ND-10-0964

Southern Nuclear Operating Company
Vogtle Electric Generating Plant Units 3 and 4
Site Safety Analysis Report License Amendment Request
Revise Backfill Geometry

**Vogtle Electric Generating Plant Units 3 and 4
Site Safety Analysis Report License Amendment Request
Revised Backfill Geometry**

SSAR Markup

Figure 2.5.2-76 Comparison of SASSI 2D Bathtub NI Model SSI Responses:Node 4535-EL 135.25 Containment Internal Structure at Operating Deck

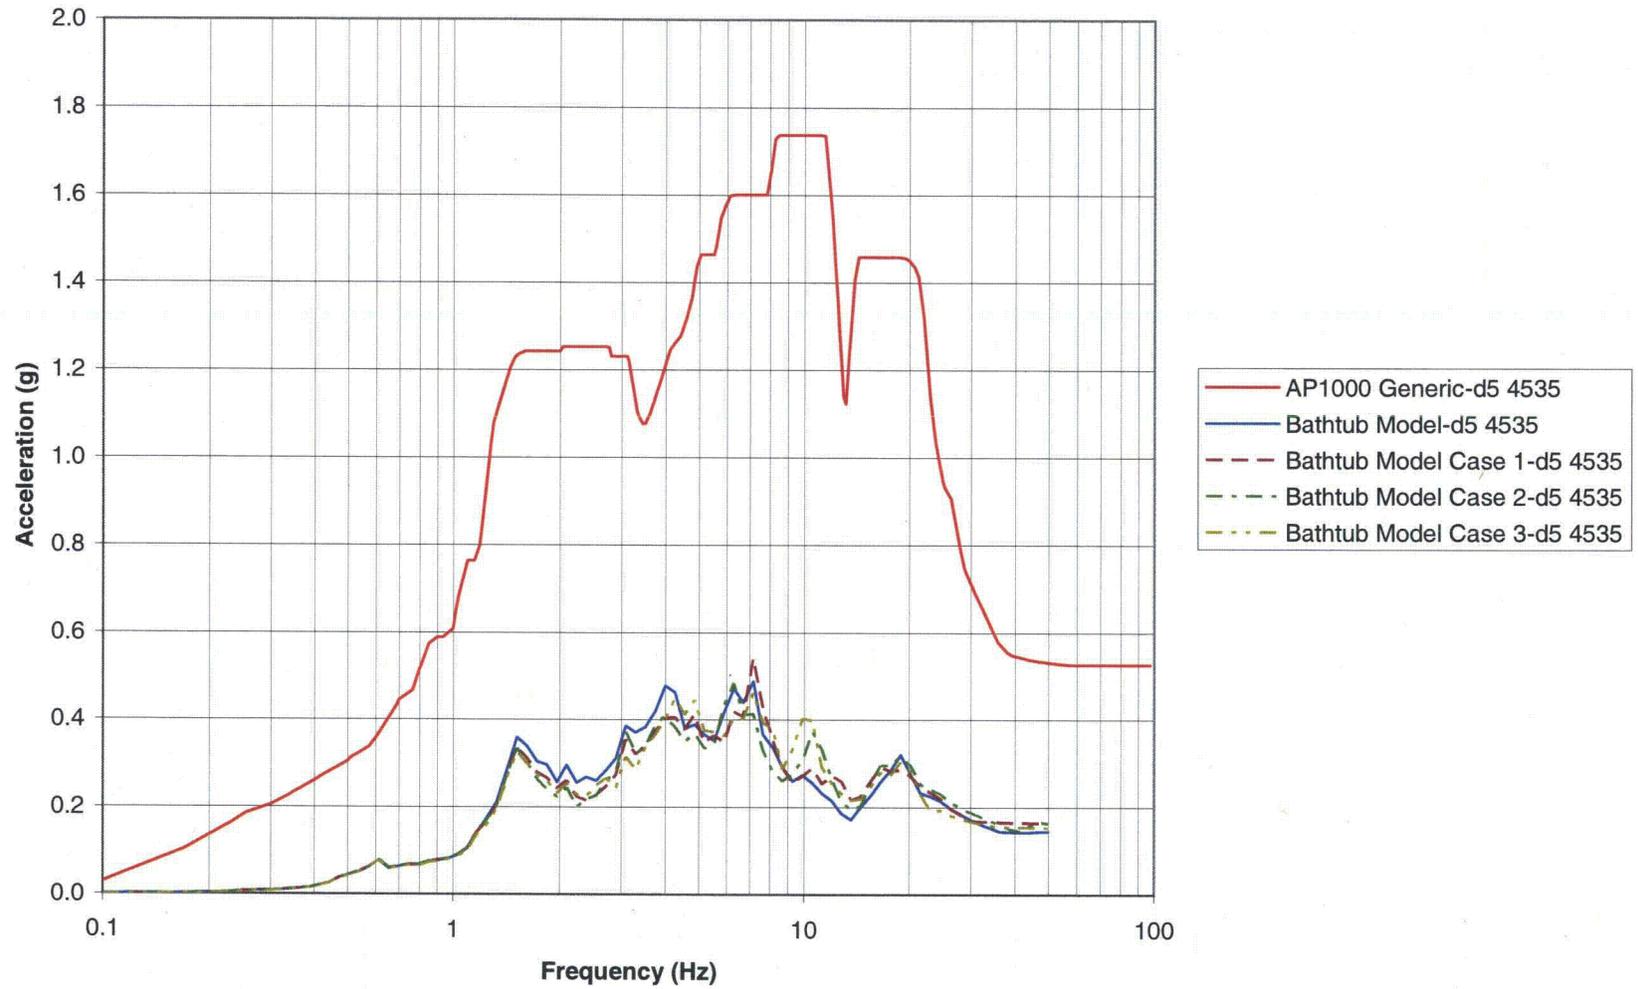
Part II of 2.5.2.9.2 provides the sensitivity study for site seismic SSI analyses. The same 2D SASSI SSI bathtub model shown in Figure 2.5.2-58 was used here except the material over the slopes was changed. Three cases described above were considered, the results of cases 1, 2, and 3 are compared to the 2D SASSI SSI bathtub results of 2.5.2.9.2. These results are the horizontal in-structure response spectra at the six key locations in the NI and are shown on Figures 2.5.2-71 through 2.5.2-76. The 2D SASSI SSI bathtub results of 2.5.2.9.2 with the Best Estimate Category 1 and 2 backfill properties used throughout the excavation are identified as "Bathtub Model-d5." The generic AP1000 standard 2D design response spectra are plotted for comparison purposes as was done in 2.5.2.9.2. As shown in these figures the differences are very small confirming that backfill with shear wave velocities lower and higher than Category 1 and 2 backfill can be placed over the slopes without invalidating the results and conclusions provided in 2.5.2.9.2.

Revised Figure 2.5.4-16 Power Block Excavation Sections

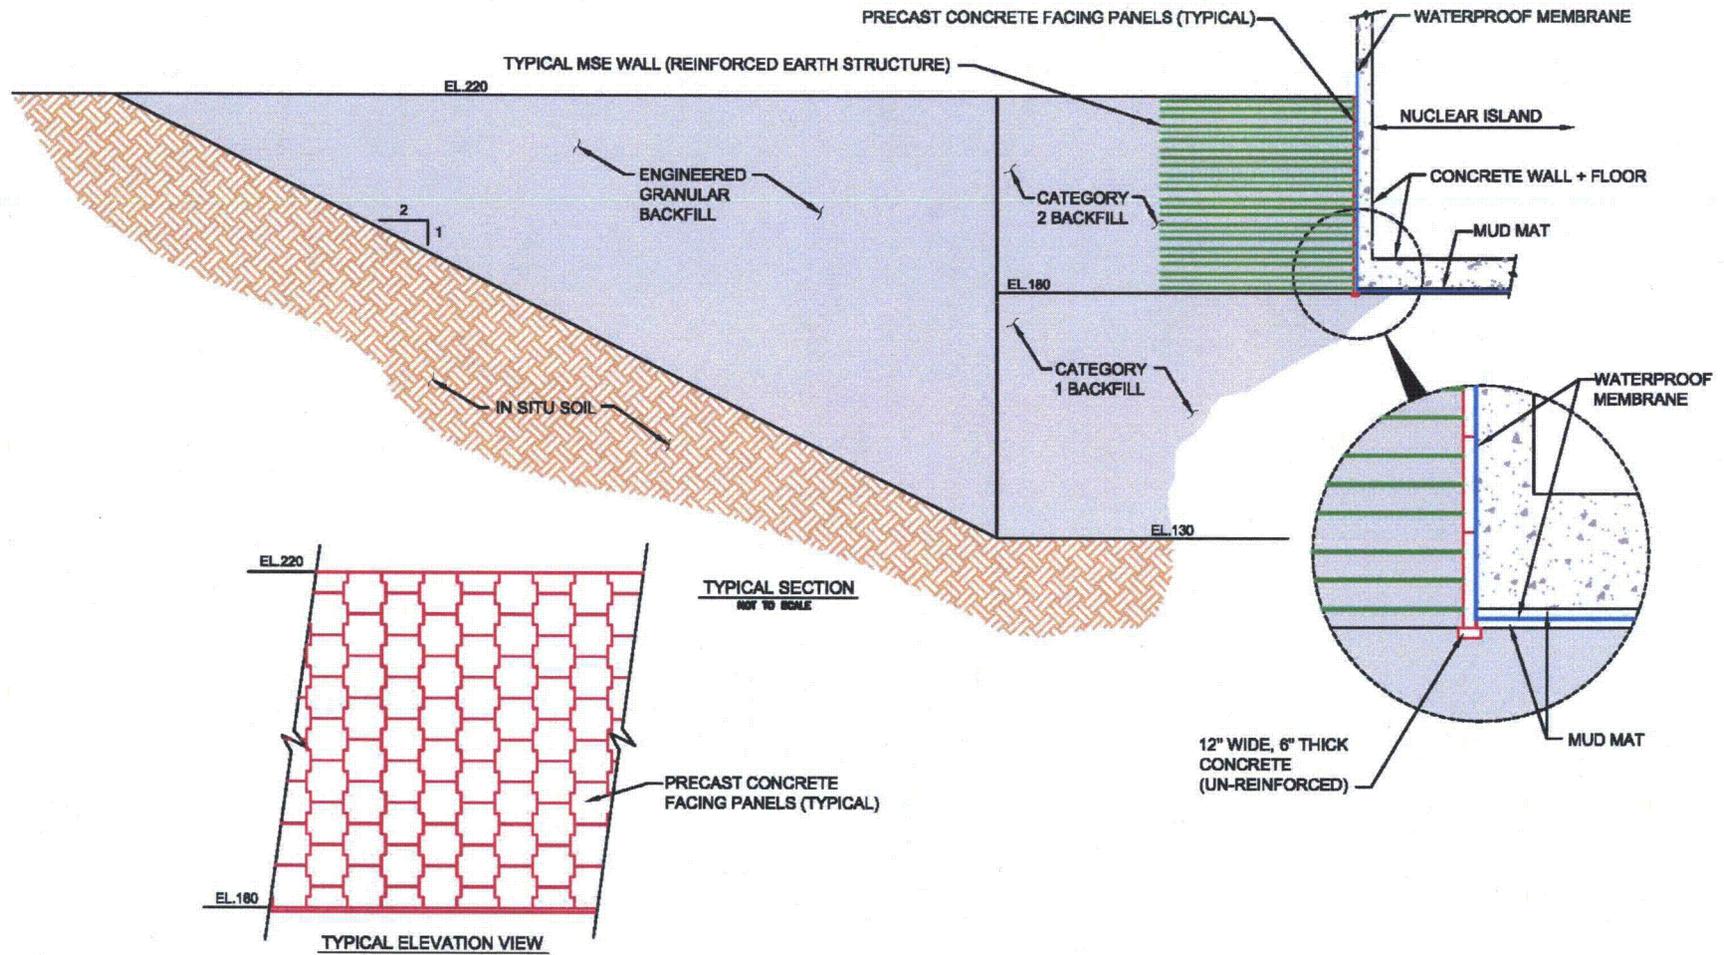
This amendment request allows the use of EGB over the slopes of the excavation. SSAR Section 2.5.4.5.1 is revised to describe the use of EGB material over the slopes of the excavation. Figures 2.5.4-16 and 2.5.4-17 are revised to depict the location of use of EGB material over the slopes of the excavation.

Engineered granular backfill (EGB) will be placed above the slopes, outside the specified lateral extent of the Category 1 and 2 backfill, as defined in Figure 2.5.4-16. The areas where EGB will be placed will not affect the static or seismic performance of the safety-related facilities. The EGB will be well-compacted granular backfill meeting the following requirements;

- Compacted to a minimum of 95% of modified Proctor (ASTM D1557) maximum dry density value
- Consist of sands, silty sands and clayey sands (SP, SP-SM, SP-SC, SW, SW-SM, SW-SC, SC, SC-SM, or SM based on the Unified Soil Classification System (ASTM D2487))
